**Sub: Final Report of Standing Committee of Experts to investigate failure of towers during the period October 2014 to June, 2015.**

# REPORT OF THE STANDING COMMITTEE OF EXPERTS ON FAILURE OF TOWERS DURING OCTOBER 2014 TO JUNE 2015

**CENTRAL ELECTRICITY AUTHORITY  
MINISTRY OF POWER  
GOVERNMENT OF INDIA  
NEW DELHI**

**Location No. 313**

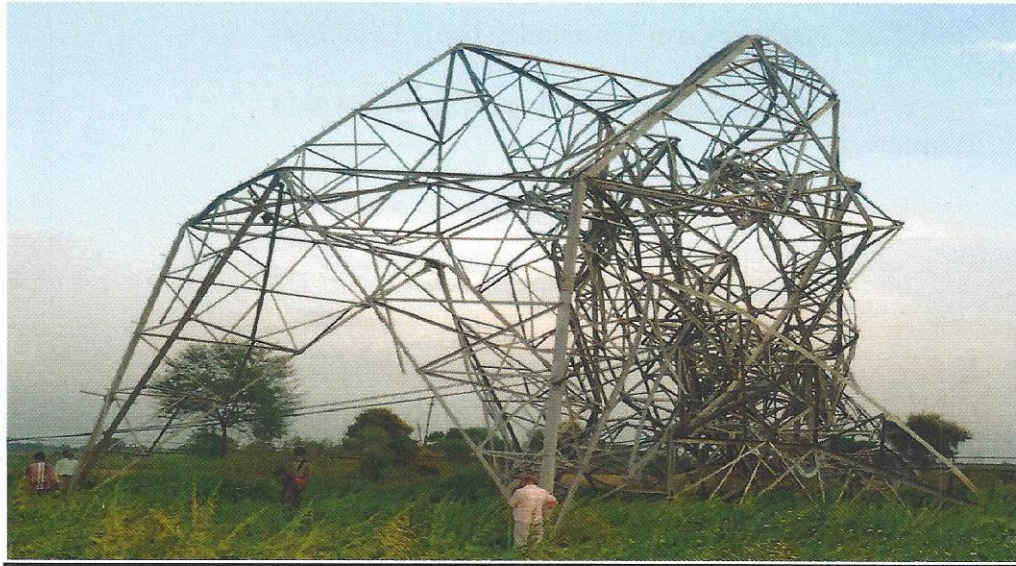
The committee noted that the pattern of failure is similar to that of 765 kV Gaya-Fatehpur S/C Line (Designed for Wind Zone-4). The strengthening of towers has to be carried out in line with above mentioned line.

**Location No. 489**

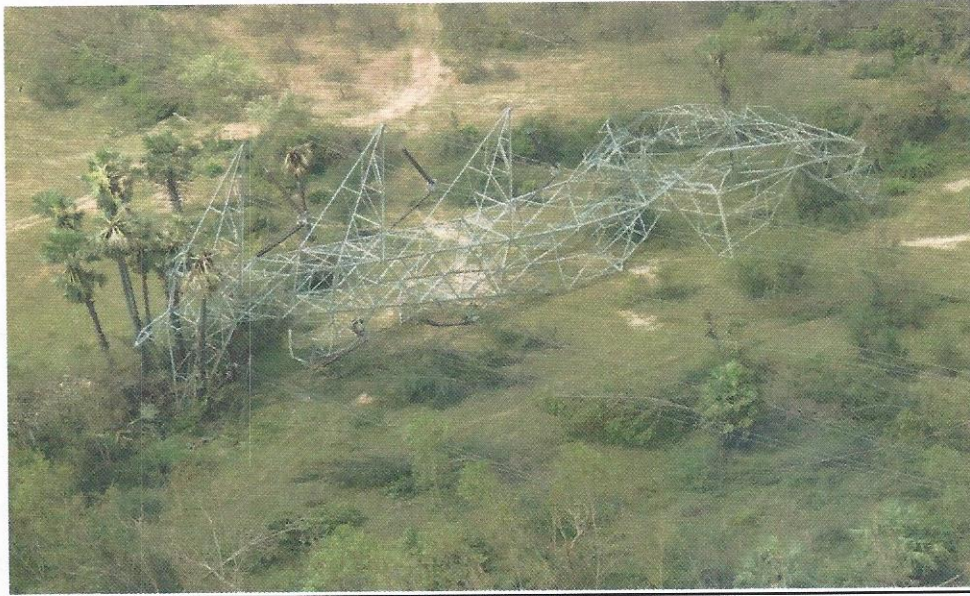
The towers have been designed according to old IS:802 (1977). Committee advised PGCIL to check the design of tower according to latest IS:802 taking into consideration narrow front wind on tower body and 75% of wind in broken wire condition for suspension towers and the strengthening of towers, if required, needs to be taken up and planned accordingly, in case more failure occurs in future. Powergrid was also requested to submit material test reports of failed towers.

**6. 400 kV Vindhyachal-Satna D/C Transmission Line Failed On 13-05-2015  
(Location no. 709)**

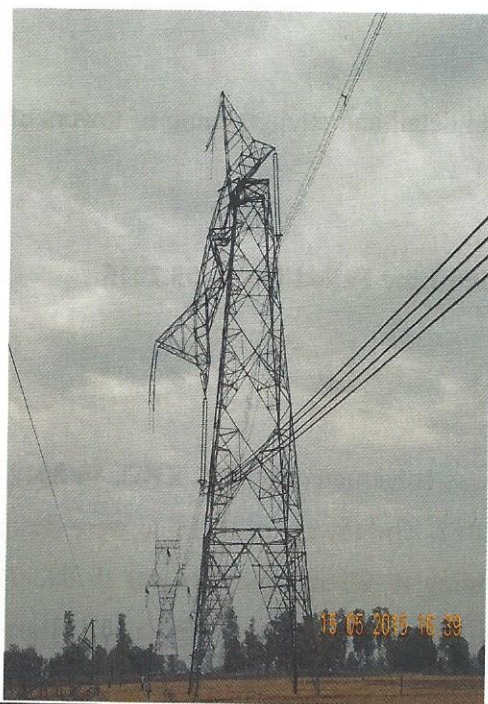
The committee recommended to review design of towers for strengthening, even though the towers were designed according to IS:802(1995), in case of more failure occurs in future.

**Location No.283**

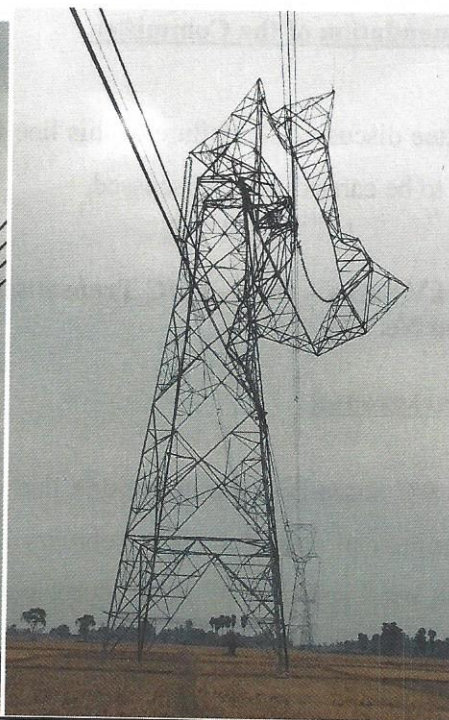
Committee discussed the failure of this line in detail and strengthening of towers of this line has to be carried out as discussed.

**Location No.181**

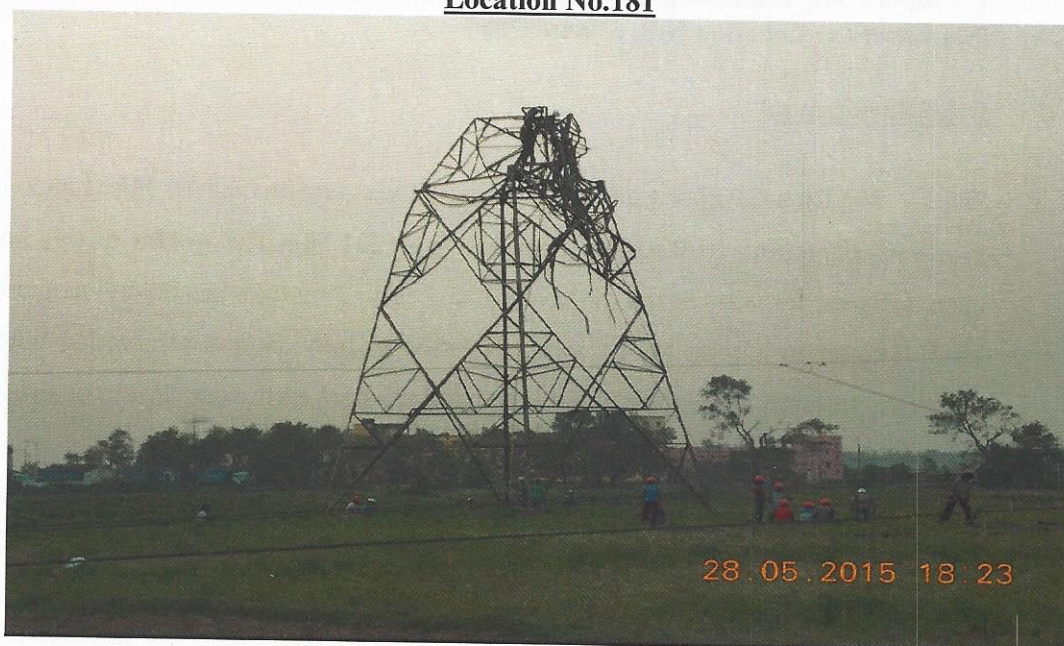
The committee noted that the pattern of failure is similar to that of 765 kV Gaya-Fatehpur S/C Line (Designed for Wind Zone-4). The strengthening of towers has to be carried out in line with above mentioned line.

#### Location No.334

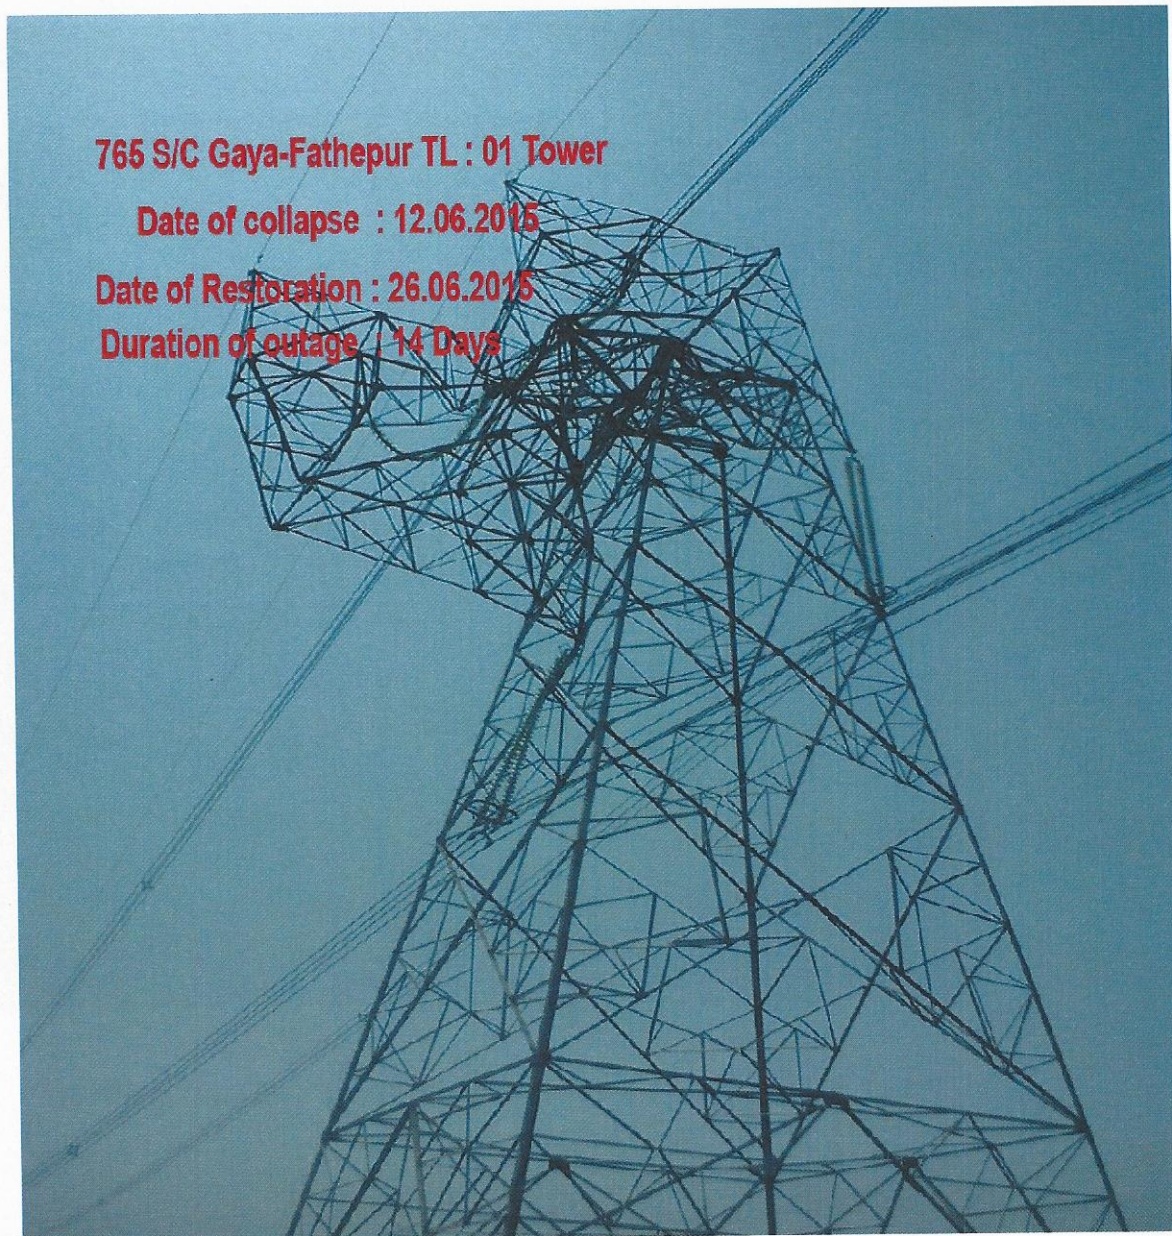
Committee discussed the failure of this line in detail and strengthening of towers of this line has to be carried out as discussed.

**Location No.51**

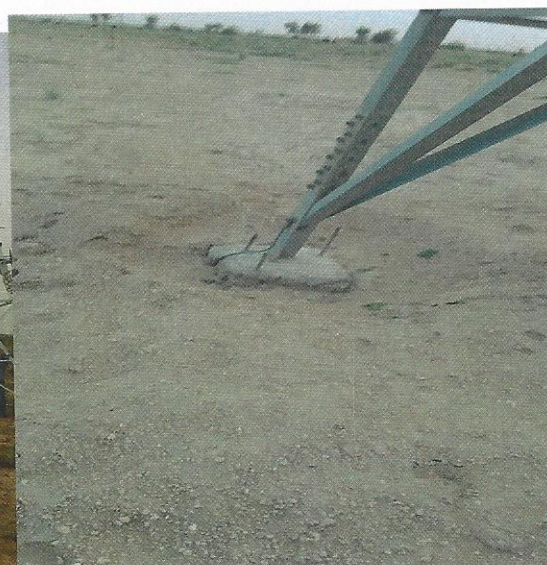
design of suspension towers. The strengthening of towers, if required, needs to be taken up and planned accordingly.
